September 30, 2013

Second Modification to EPA's Final Determination for the South Terminal Project – Additional Dredging and Blasting for Rock Removal

SECOND MODIFICATION SUMMARY: After completing consultation with other federal and state agencies, as required by federal and state law, and after reviewing additional submissions by the Commonwealth, EPA has determined that the Commonwealth's request for a Second Modification to EPA's Final Determination for the South Terminal Project, issued on November 19, 2012 ("the Final Determination" or "FD"), is both protective of human health and the environment, meets the substantive requirements of applicable or relevant and appropriate federal environmental standards and, through the Commonwealth's determination, meets applicable or relevant and appropriate state environmental standards, as long as the conditions set forth in this Second Modification are met. Through this Second Modification to the Final Determination, EPA is modifying the South Terminal Project portion of the State Enhanced Remedy ("State Enhanced Remedy" or "SER"), which is incorporated into the 1998 Record of Decision for the Upper and Lower Harbor at the New Bedford

**Figure 1
Map of 200' Northern Dredging Expansion of Deep Draft
Area**

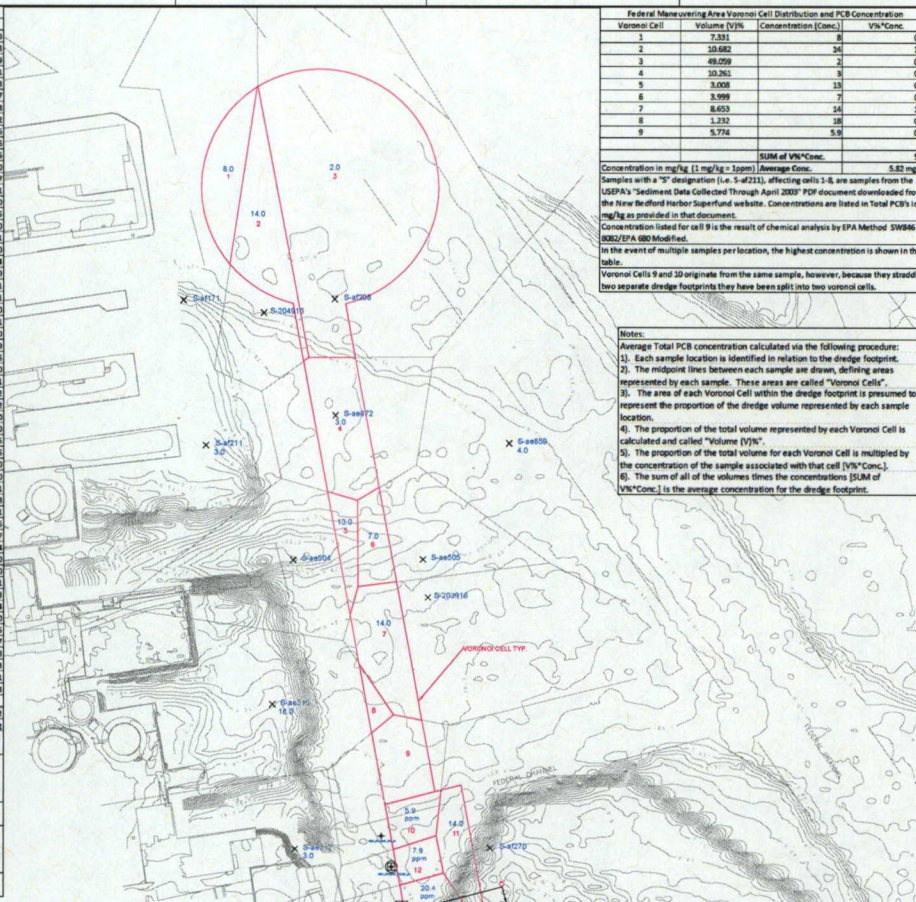
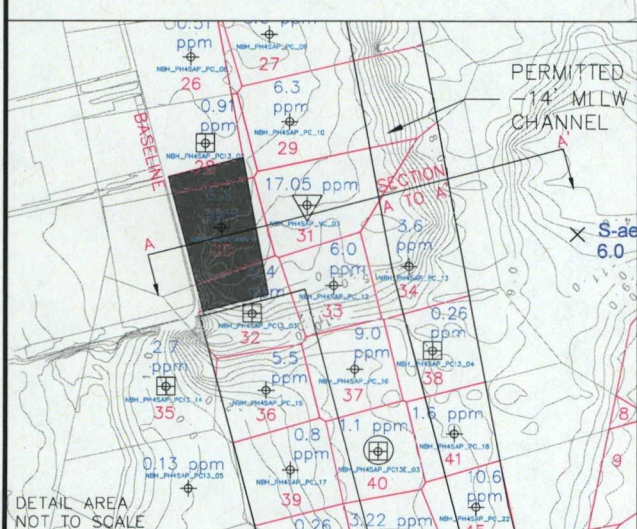
The additional dredging at the deep draft berthing area would extend north by 200 feet the area authorized in the Final Determination, beginning at the southeastern edge of the existing Shuster bulkhead and ending at the northeast corner of the Shuster bulkhead, resulting in a total of 800 feet of deep draft area along the South Terminal facility. Depths will change from the existing -20 MLLW to a depth of -32 MLLW. Approximately 2,500 cubic yards of contaminated sediment and 8,000 cubic yards of clean sediment will be generated by this expansion. Contaminated sediment will be disposed in CAD cell 3; clean dredged material will be used as fill during construction of the terminal. See map at Figure 1.

Figure 2
Map of 50' Widening of Channel

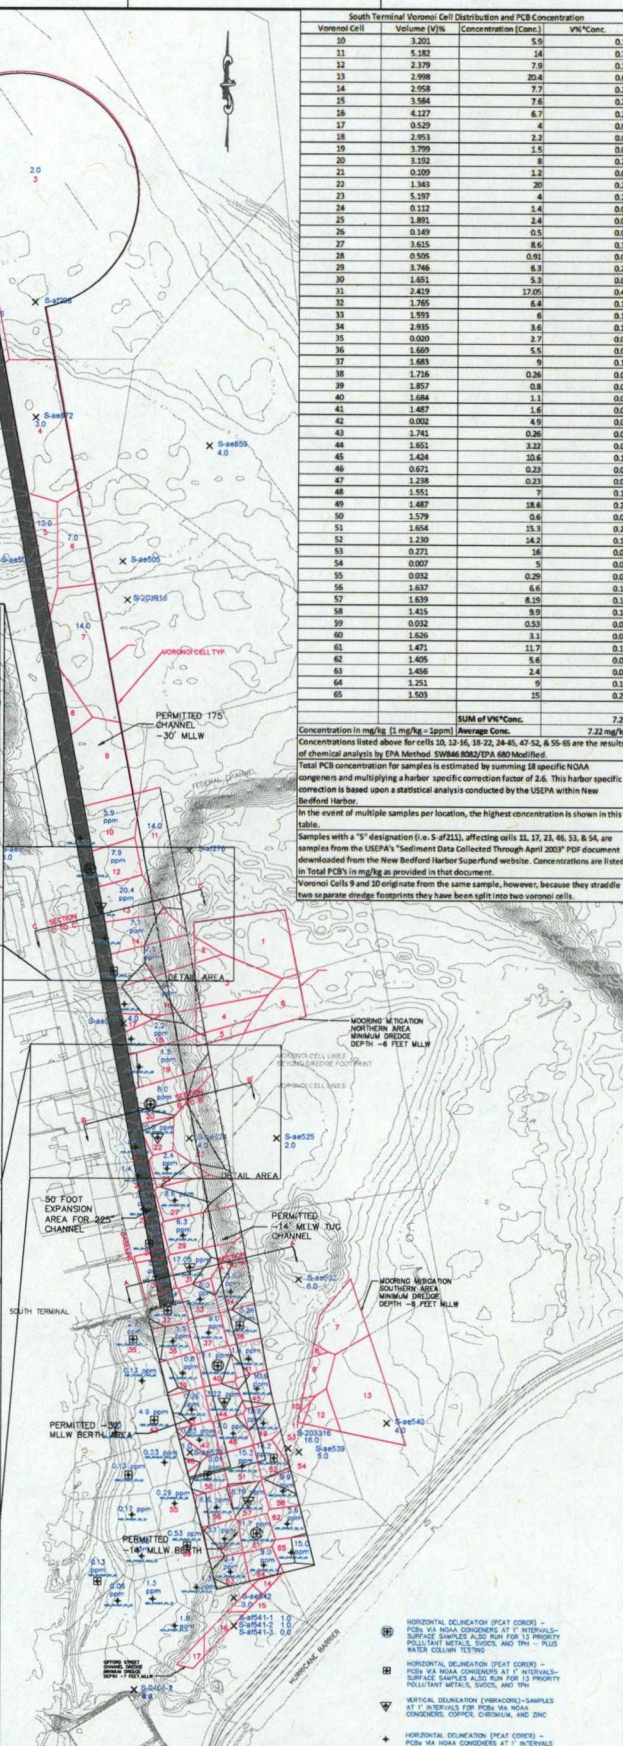
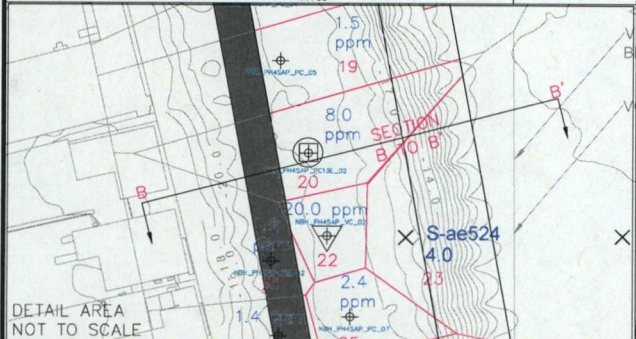
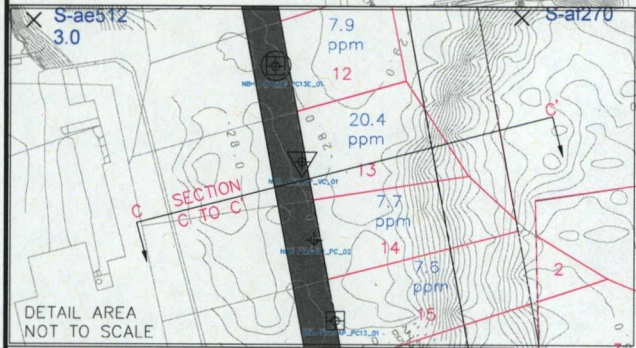
The additional 50 foot width channel expansion will occur on the western, or landward, side of the 175 foot channel authorized in the Final Determination. This area west of the channel is already at a depth of -20 to -30 MLLW and will only need slightly more dredging to bring it to -32 MLLW, generating approximately 8,500 cubic yards of contaminated material and 7,000 cubic yards of clean material. Disposal of the contaminated and clean dredged material will be the same as disposal of the deep draft dredged material. See map at Figure 2.

**Figure 3
Map of Three Blast Areas**

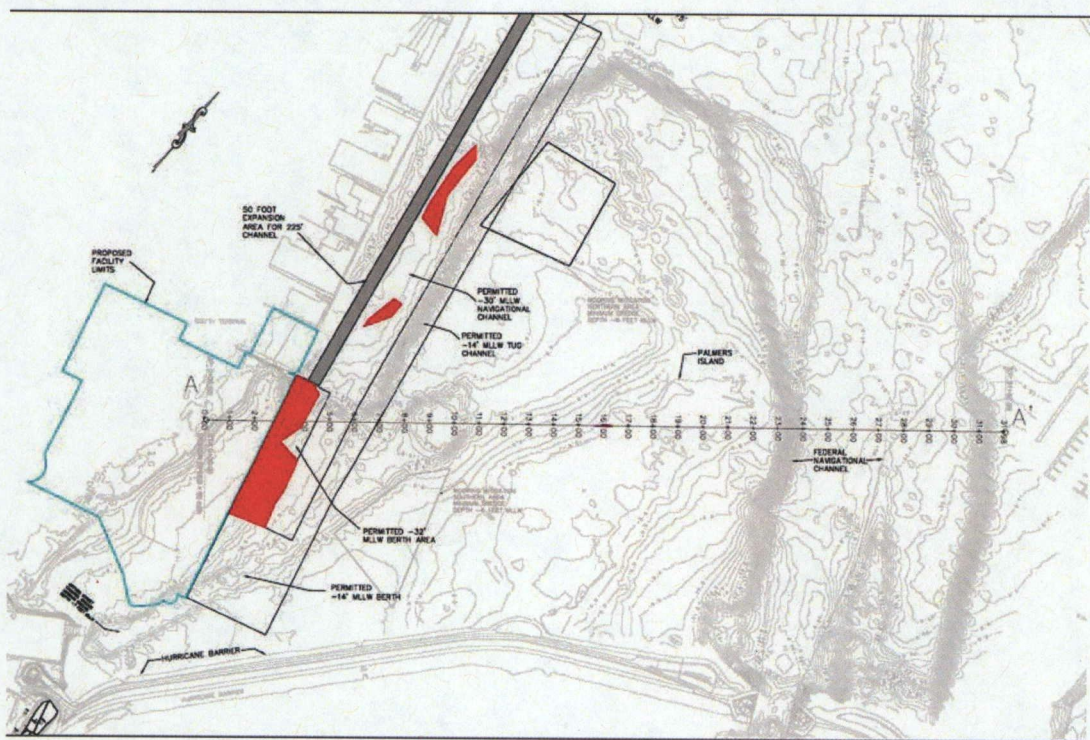
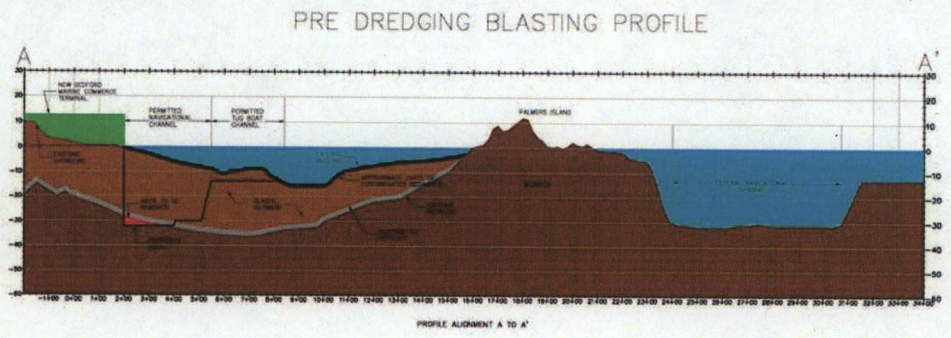
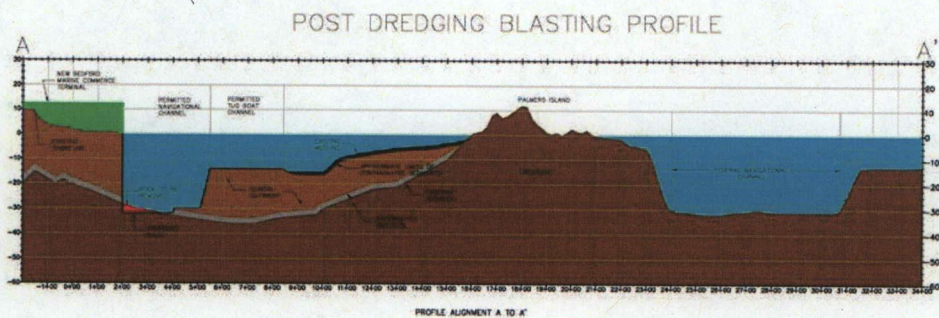
The intersection of shallow rock and the overburden is located very close to the bottom of the dredge footprint primarily along the immediate eastern face of the bulkhead in the deep draft dredge area. Three areas may require blasting, one in the vicinity of the berthing area and the other two in the approach channel (See Figure 3). Before blasting occurs, all contaminated sediment will be removed, leaving a clean overburden layer above the bedrock. This overburden layer will remain in place during blasting to provide a positive dampening effect on the acoustical impacts of blasting. A drill rig will then drill through the rock to an appropriate depth and blast charges of varying amounts up to 150 pounds per delay, depending on the thickness of the rock, will be placed into the holes. A technique call "stemming" will be used which consists of placing crushed rock into the top of the hole to further dampen the shock wave reaching the water column that will assist in reducing fish mortality. A two hour Notice to Blast will be given at the

2. Blasting shall only be conducted in the three locations depicted on page 4 of the Commonwealth's May 20, 2013 letter to EPA (See Figure 3 of this document). Blasting at the site closest to the bulkhead construction area may occur between September 15 and January 15. Blasting at the other two locations may occur between November 15 and January 15, and might also be able to occur earlier than November 15 if EPA specifically approves in writing an earlier start date for one or both sites following completion of the blasting at the bulkhead site and EPA's evaluation of the monitoring results (discussed further below).

Figure 4
Map of Winter Flounder Mitigation Area

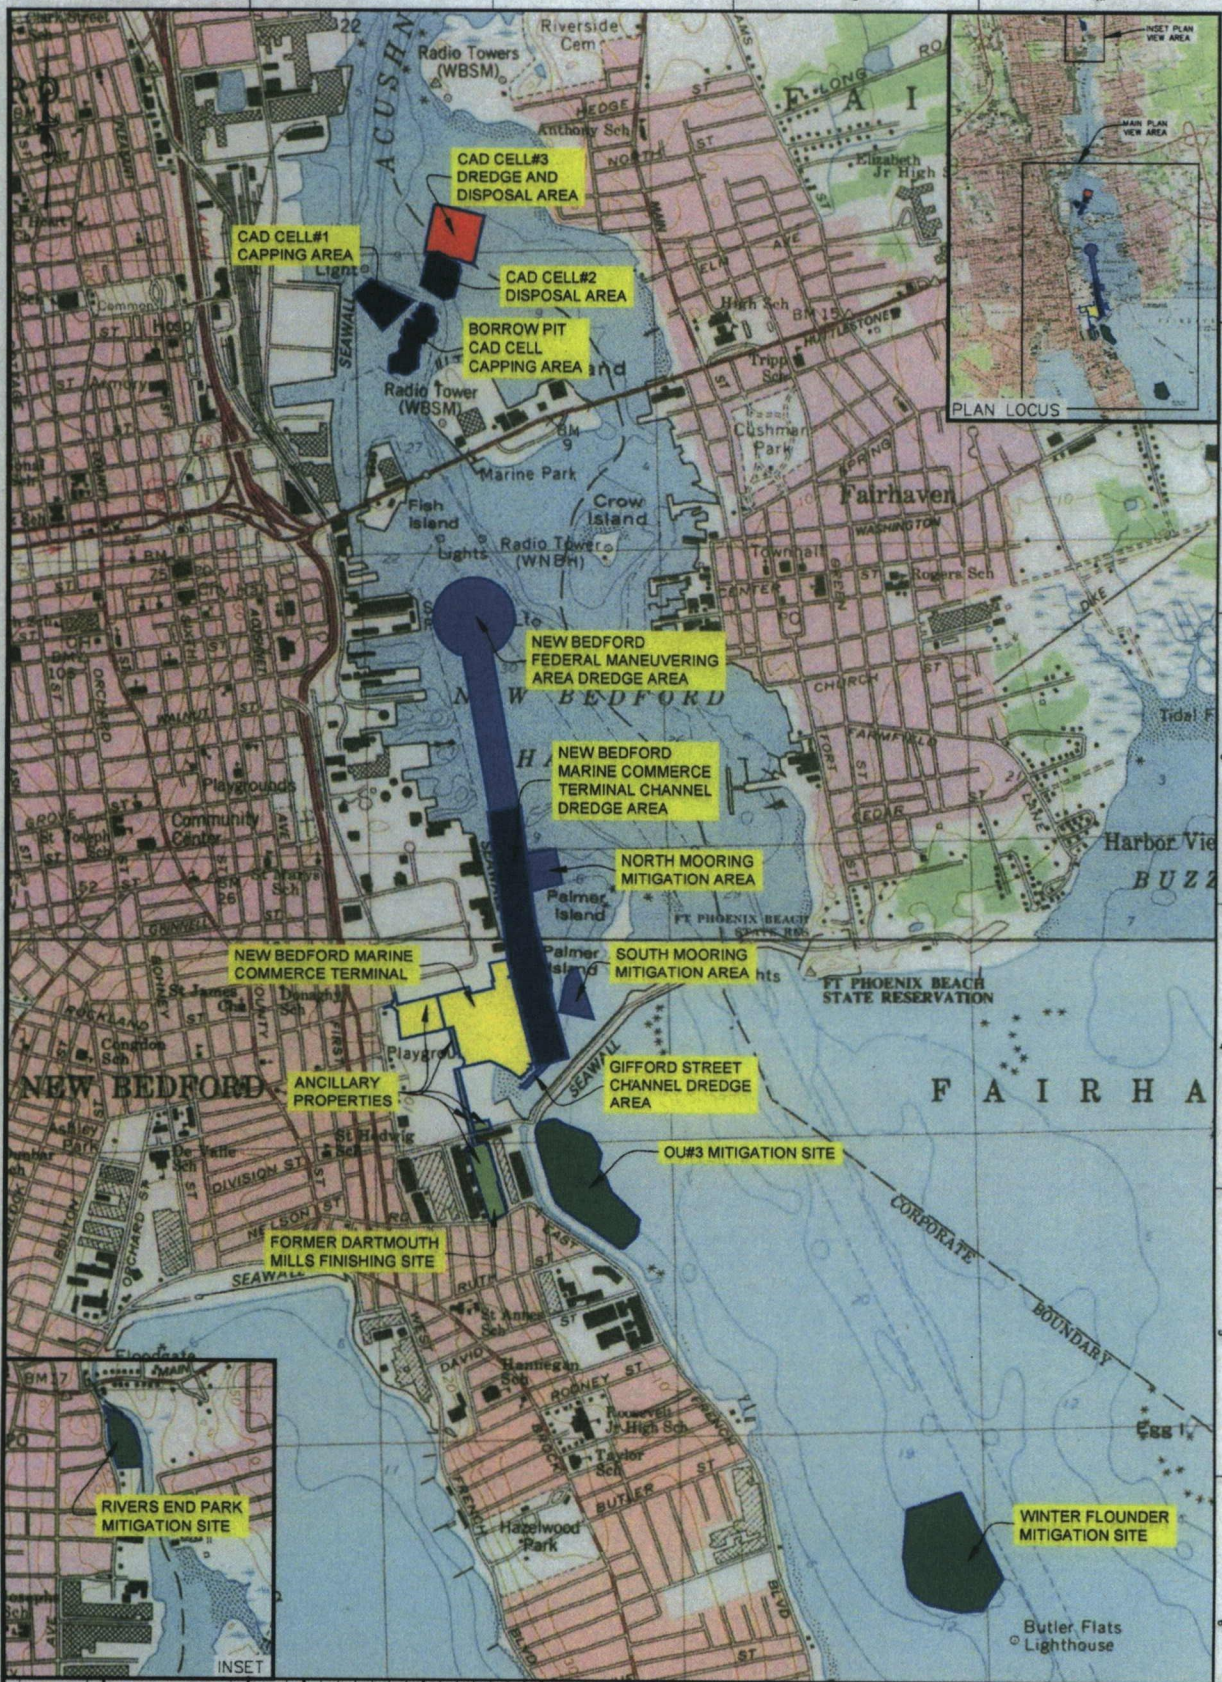
Within the Final Determination, EPA issued Water Quality Performance Standards (Final Determination Appendix C) that included a requirement that at any depth and at all times of the year, silt curtains be used during filling and capping activities associated with compensatory mitigation, including the winter flounder mitigation area. A copy of Figure 1 of Final Determination which depicts the winter flounder mitigation area is attached as Figure 4 to this document.

After reviewing the Commonwealth's request, as well as the Fish Deterrent Weekly Reports provided by the Commonwealth from January 15 through June 15, 2013 and the alternate measures proposed in the letter dated April 19, 2013 from the Commonwealth to EPA for reducing and monitoring turbidity at the winter flounder mitigation area, and based on its own experience, EPA, by letter dated May 15, 2013, modified Section II.5.b of the Water Quality Performance Standards to waive the requirement for the use of silt curtains at the winter flounder mitigation area when there is filling and capping associated with compensatory mitigation as long as the conditions set out in that letter, and incorporated herein through the Revised Water Quality Performance Standards (Appendix C), are met. This modification does not alter the requirement that silt curtains be used during filling and capping associated with compensatory mitigation in intertidal and subtidal mitigation areas, and the Commonwealth must continue to meet all other requirements of the Water Quality Performance Standards.

Figure 5
Map of 1500 foot zone for potential vibrations from
blasting

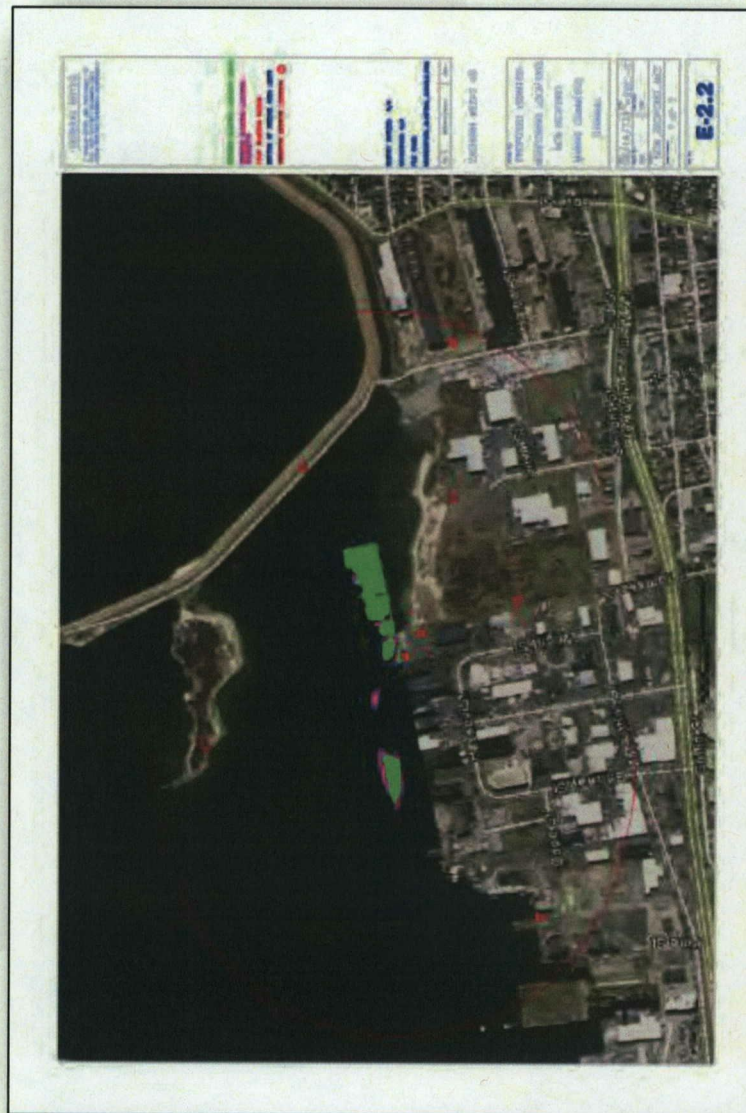
In addition, the Commonwealth will take real-time measurements of the actual vibrations at the Light Station that are generated during blasting to confirm modeling results. In the unlikely event that actual vibrations exceed modeling results and/or impacts are detected, the Commonwealth must provide immediate notification to EPA. The Agency will then immediately engage in consultation with appropriate parties to discuss and implement measures to avoid, minimize or mitigate potential impacts to the Light Station.

An additional historic property, the Palmer Island Light Station (the Light Station), has recently been identified within the Project area that was not included within the scope of the original assessment. More specifically, the Light Station is located within the 1500 foot zone where potential vibrations may occur from blasting. See Figure 5.
